<b>WEST SUSSEX COUNTY COUNCIL CONSULTATION</b>	
<b>TO:</b>	Mid Sussex District Council
<b>FROM:</b>	WSCC Education – School Organisation
<b>DATE:</b>	19 June 2025
<b>LOCATION:</b>	Land East of Ansty Way Cuckfield Bypass Cuckfield West Sussex
<b>SUBJECT:</b>	DM/23/2866 Outline planning application (All matters reserved except for access) for the redevelopment of land to the east of Ansty to create a new Garden Community, comprising of the erection of up to 1,450 homes (including 30% affordable housing), up to 90 residential care units (C2 class), a primary school, a SEND school, health hub, sports facilities including all weather hockey pitches and tennis centre, allotments, retail, community and employment uses together with ancillary and associated development including new and enhanced pedestrian/cycle routes, open spaces, and landscaping. (Additional information and amended plans received 27th May 2025).

<b>CASE OFFICER:</b>	Steve Ashdown
<b>RECOMMENDATION:</b>	WSCC Education’s formal recommendation is as follows: <ul style="list-style-type: none"> <li>a) <del>No Objection</del></li> <li>b) <del>Conditional approval</del></li> <li>c) <del>Deferral</del></li> <li><b>d) Refusal</

Figure 9.2: Assessment of external noise levels for educational purposes  $L_{Aeq, 30mins}$

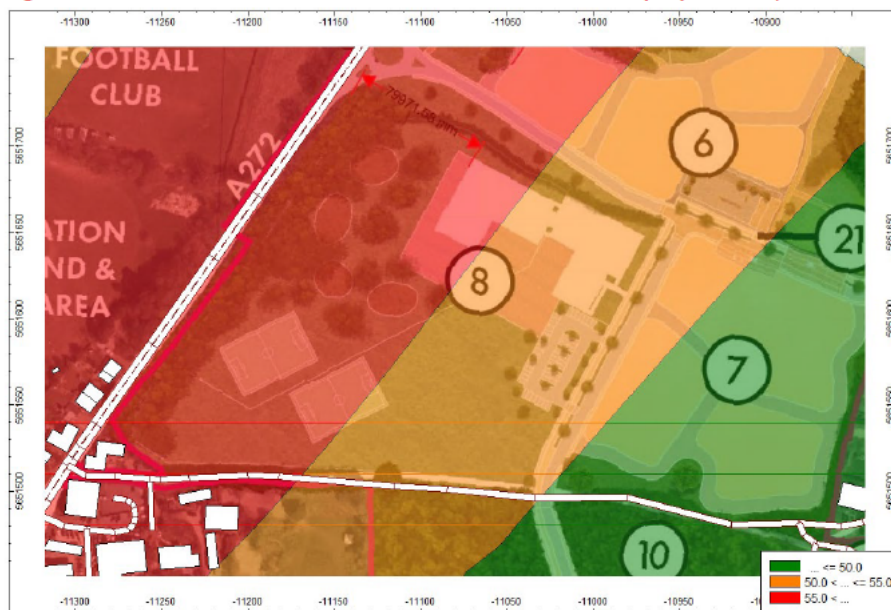
2.3.1 The following graphic illustrates external noise levels affecting the school site. All the proposed school site is affected by noise levels above 50db, with levels in the red zone ranging from 55 to 69db. The Department for Education's Building Bulletin 93 requires school playgrounds to have a baseline less than 55db and outdoor teaching less than 50db. Were the proposed educational site to progress, the internal and external spaces would need to be carefully designed with enhanced acoustic treatment to mitigate the noise pollution.
